PUBLIC NOTICE
WOODLAND PARK PLANNING COMMISSION
Thursday, March 23, 2023, 6:30 P.M.
Council Chambers – 220 W. South Avenue

City of Woodland Park Revised Staff Report for Planning Commission

SUB#2022-06: Stone Ridge Village Filing No. 5. Final Plat. A request by Dana Duncan, Stone Ridge Village, LLC. (Property Owner) and Skip Howes (Applicant and Project Coordinator) to approve a major subdivision of 7.95 acres platted into 18 lots with easements and road rights-of-way in the Stone Ridge Village Planned Unit Development (PUD) situated to the North and West of the existing intersection of Firestone Drive and Stone Ridge Drive. The property is located in the S1/2 of the NE1/4 of Section 14, Township 12 South, Range 69 West of the 6th P.M. in the City of Woodland Park, Teller County. (QJ) *Continued From March 9, 2023.*

Figure 4: Filing No.1
Final Plat

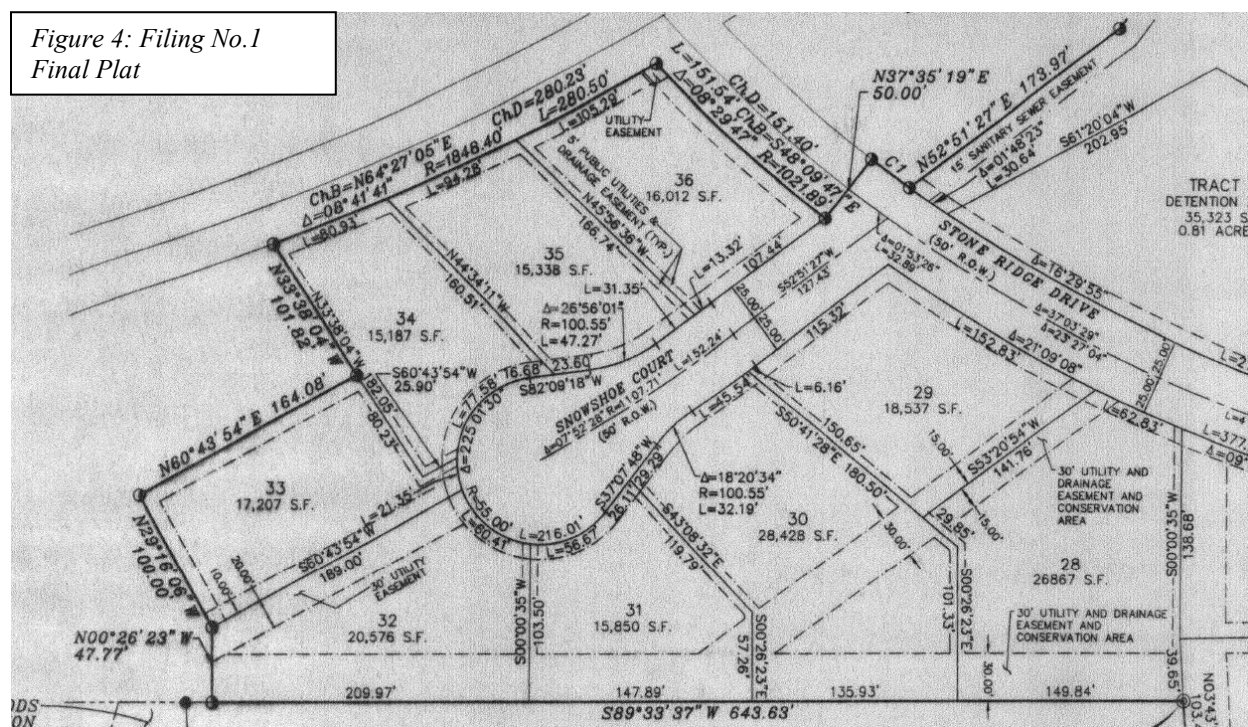
The other item to note is, in Stone Ridge Filing No. 1, at the end of Snowshoe Court there is a 30-foot utility easement between Lots 32 and 33 (as seen on Figure 4). There is an 8" water main and an 8" sanitary sewer main in this easement. The construction drawings for this filing show the 8" water main connecting with the water main in Michael Lane. Consistent with the preliminary plat, this easement needs to be extended into the southeast corner of Lot 17 of the proposed plat for filing No. 5.

U1.1

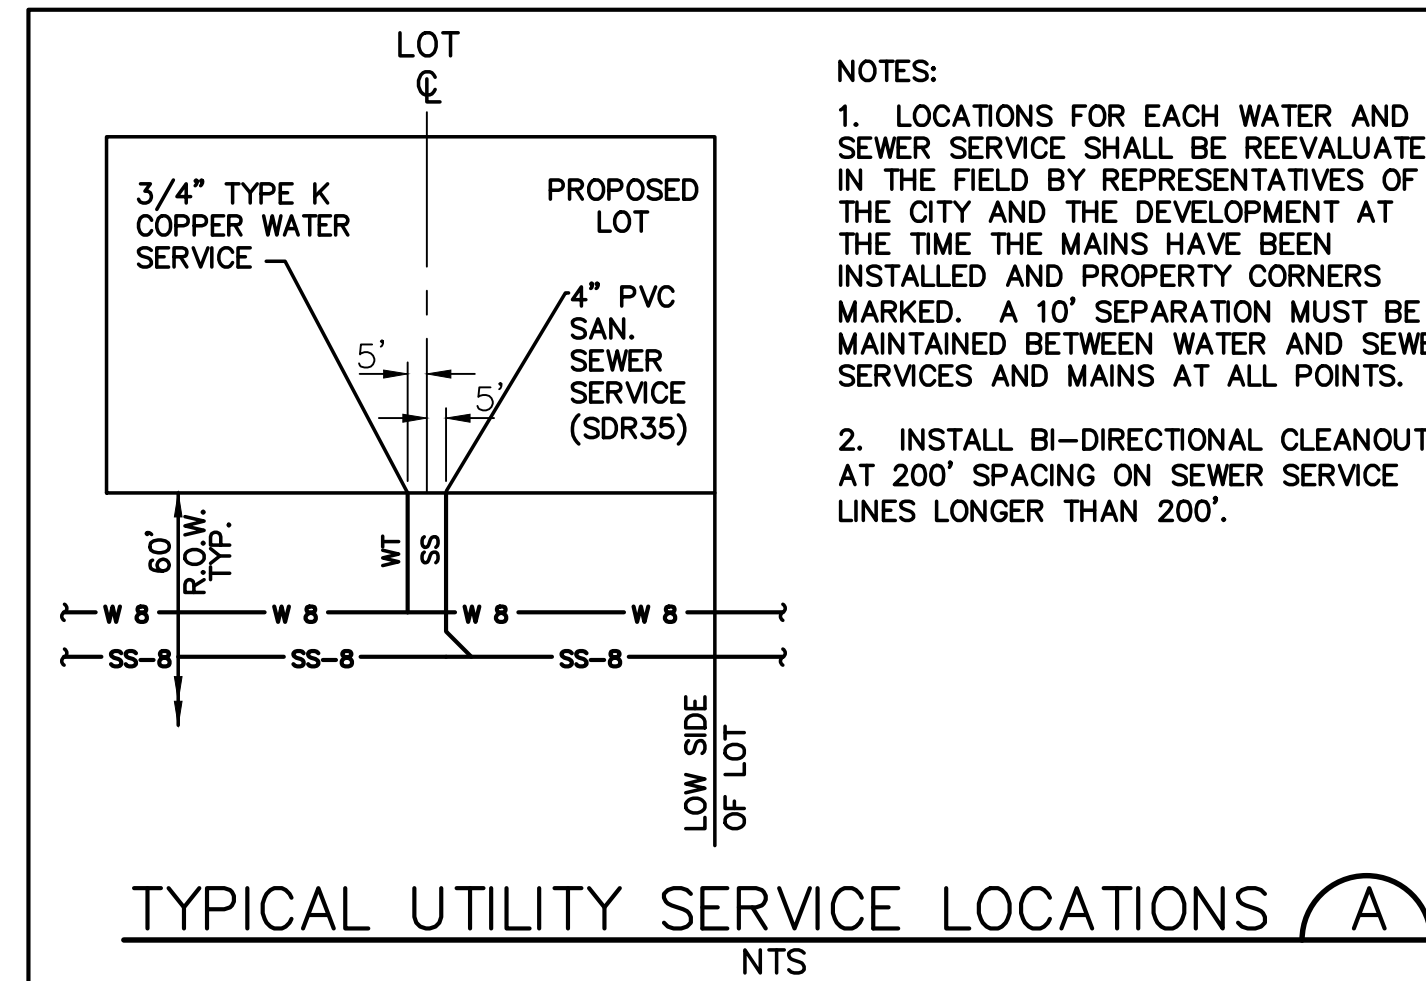
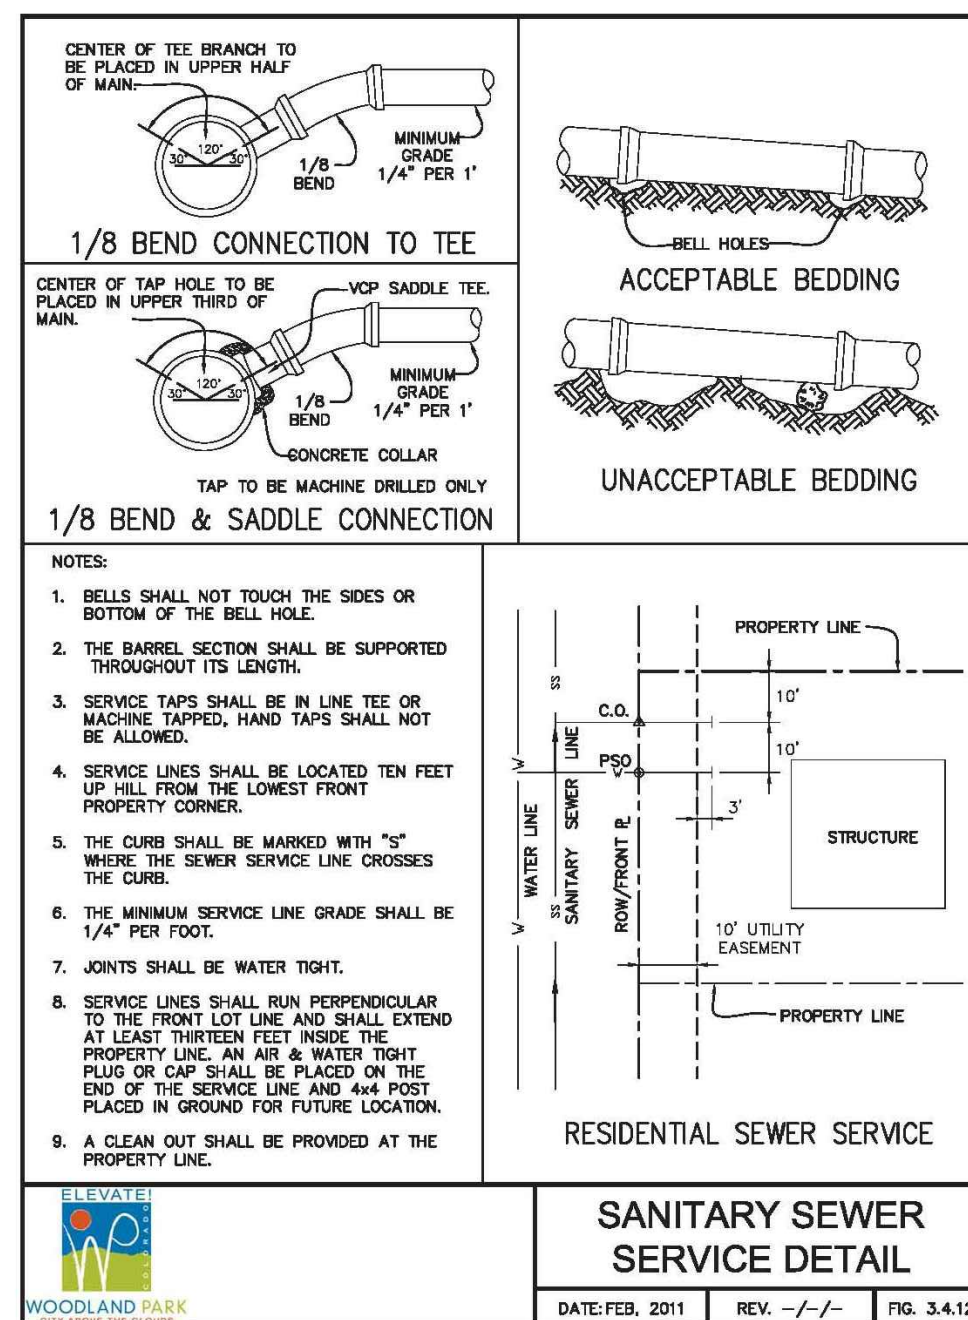
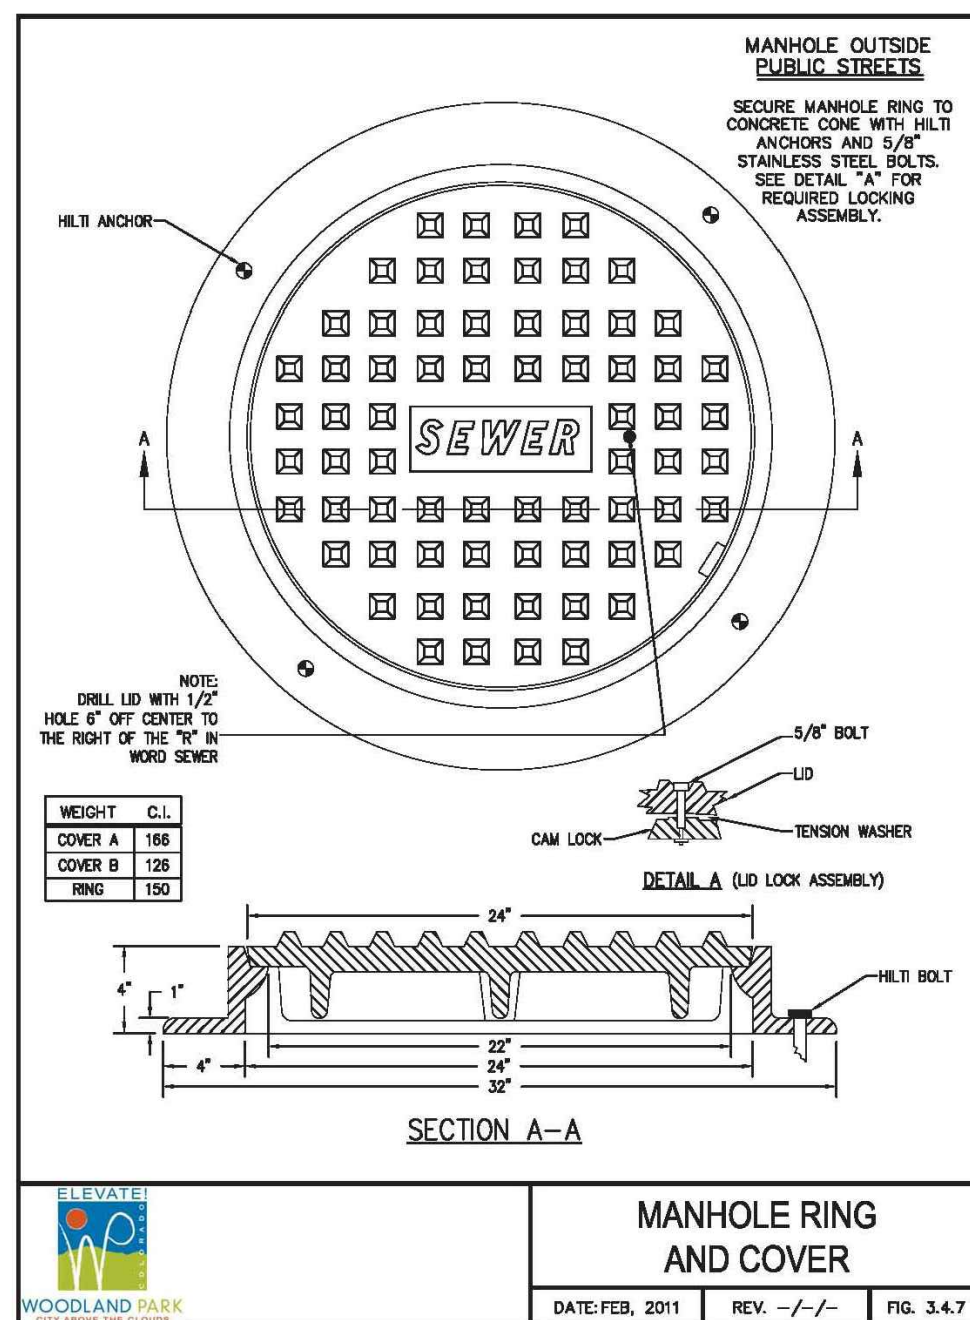
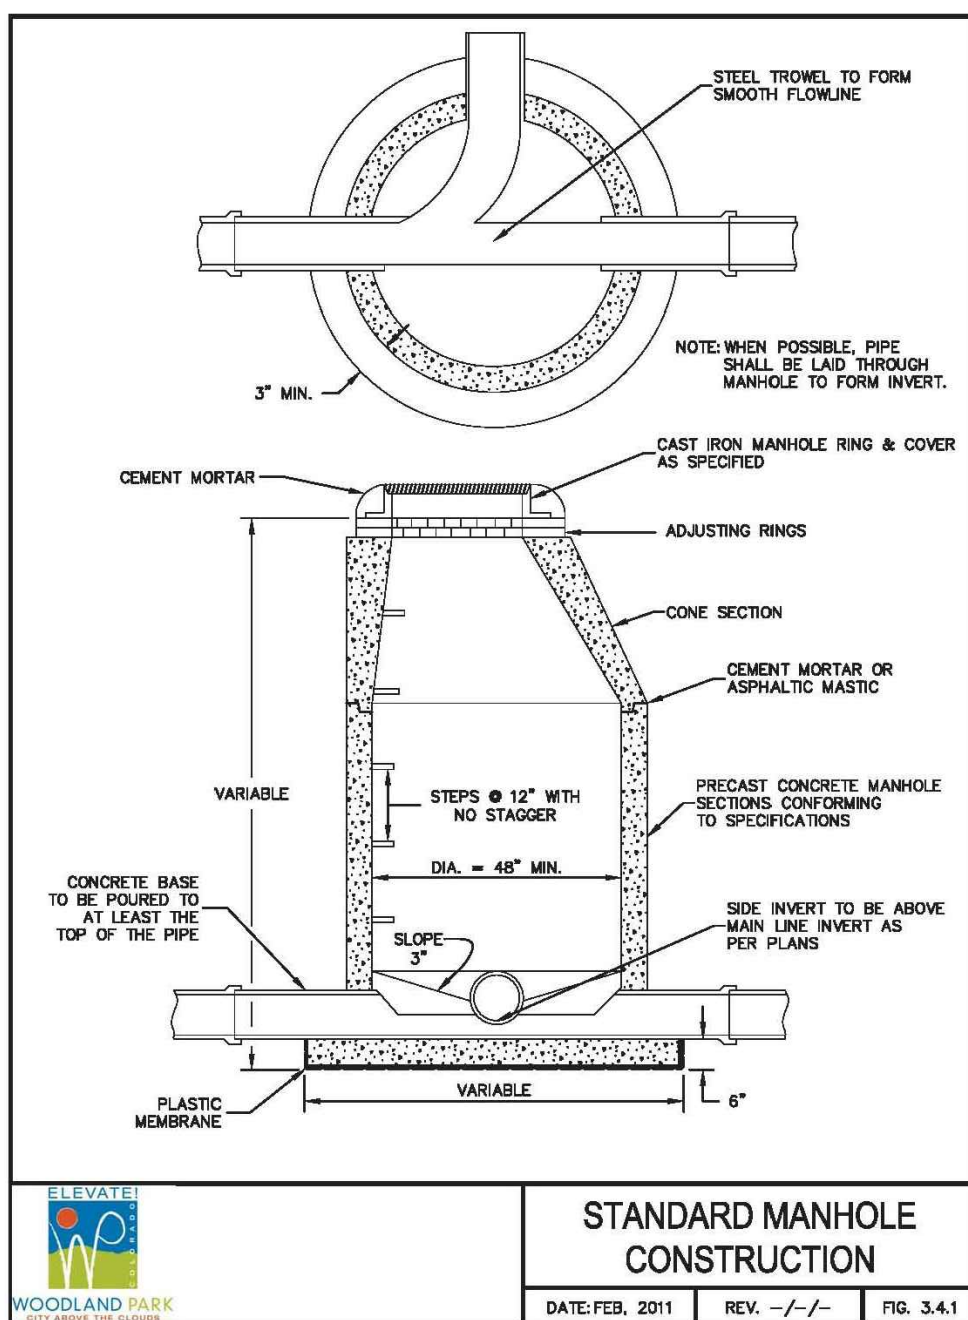
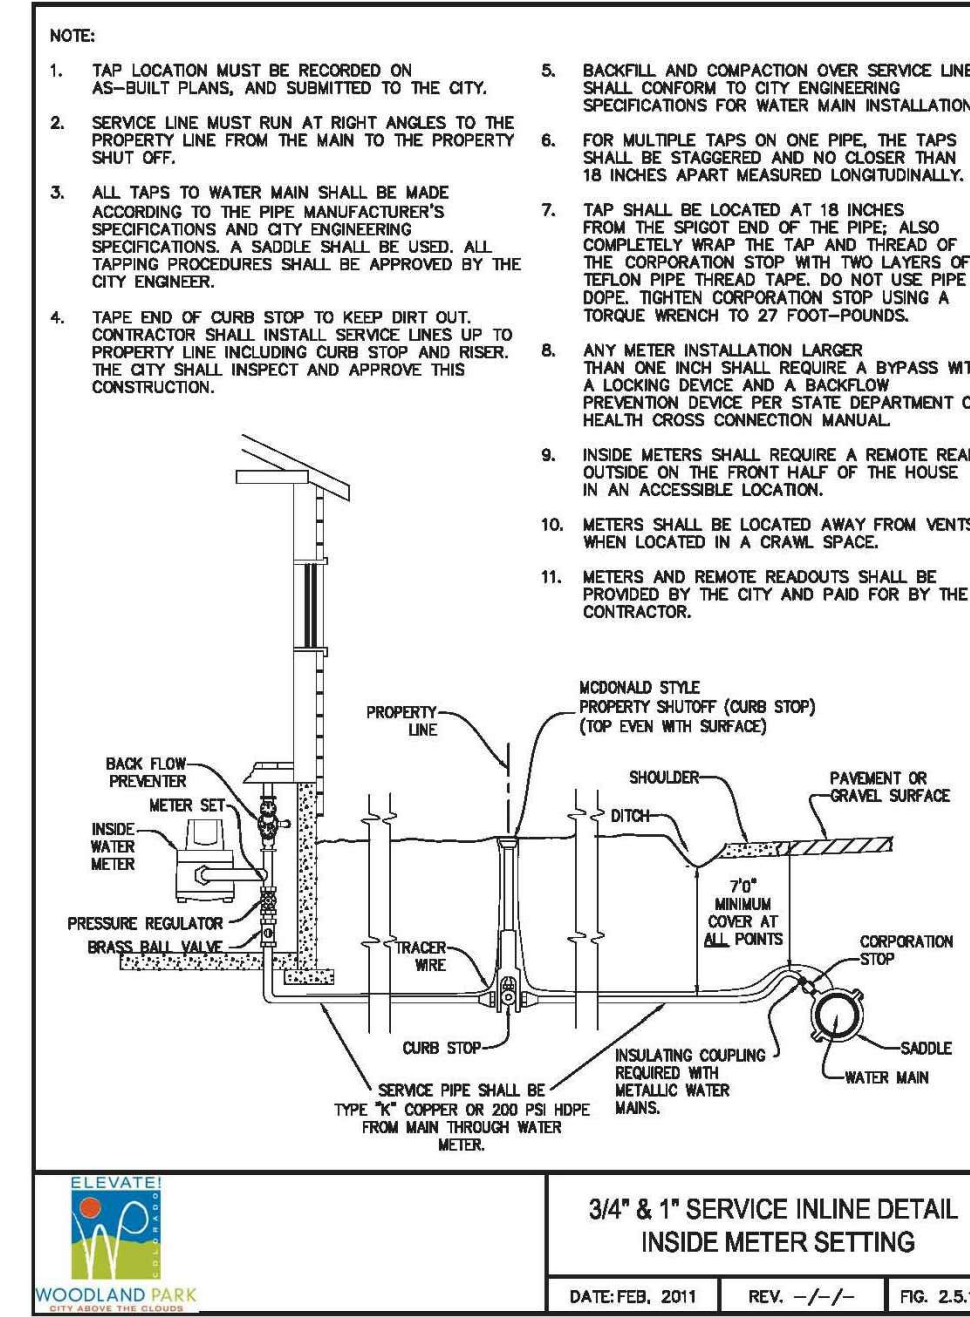
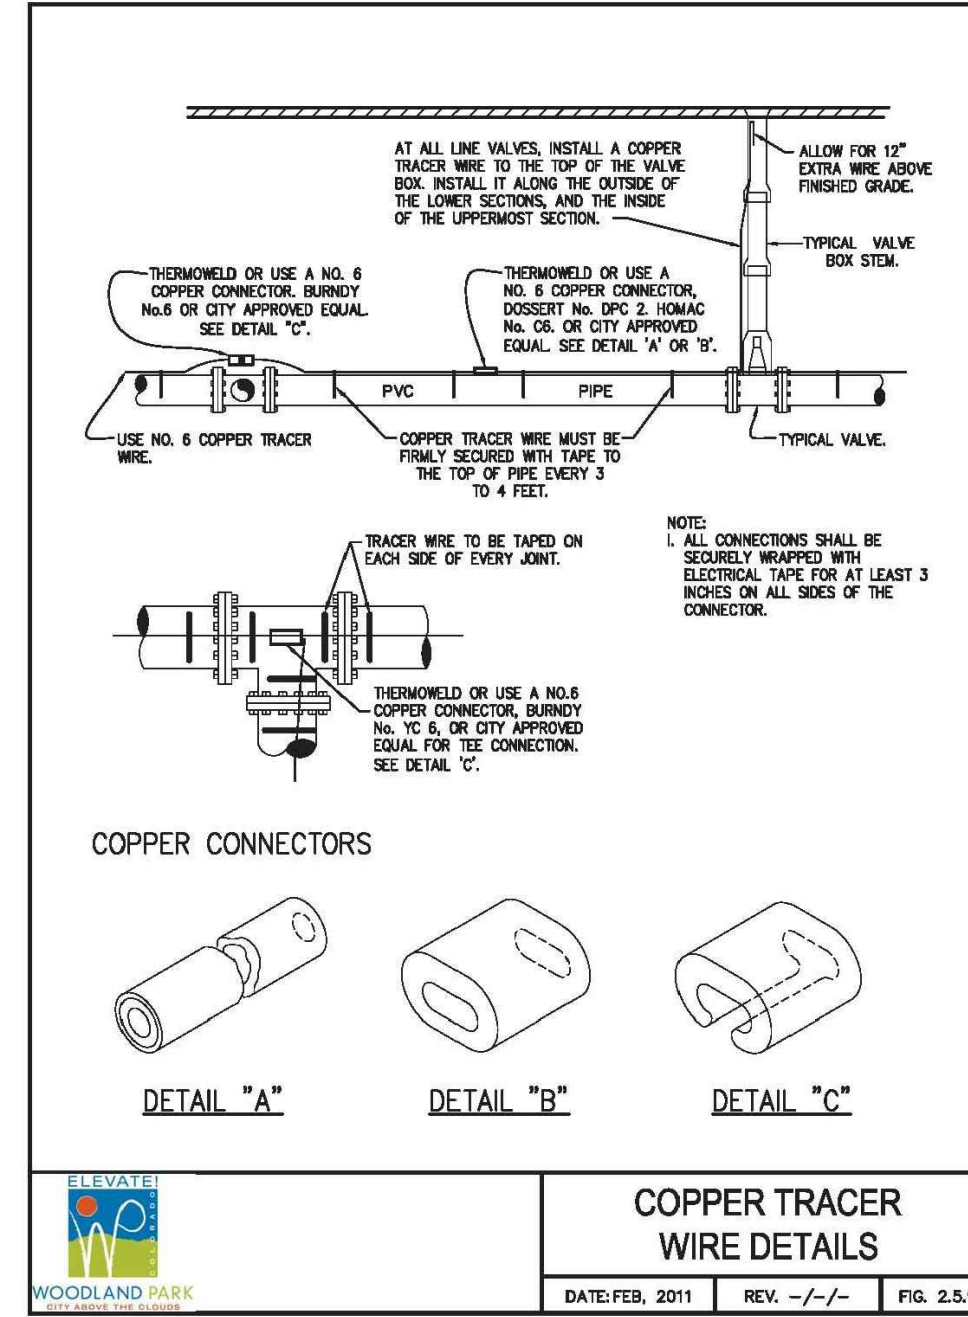
The Hydrant location offsets put the hydrant exactly on the edge of sidewalk along Firestone. Prior to initial acceptance, the hydrants will be inspected to verify no part of the hydrant encroaches on the sidewalk, or the hydrants will need to be relocated.
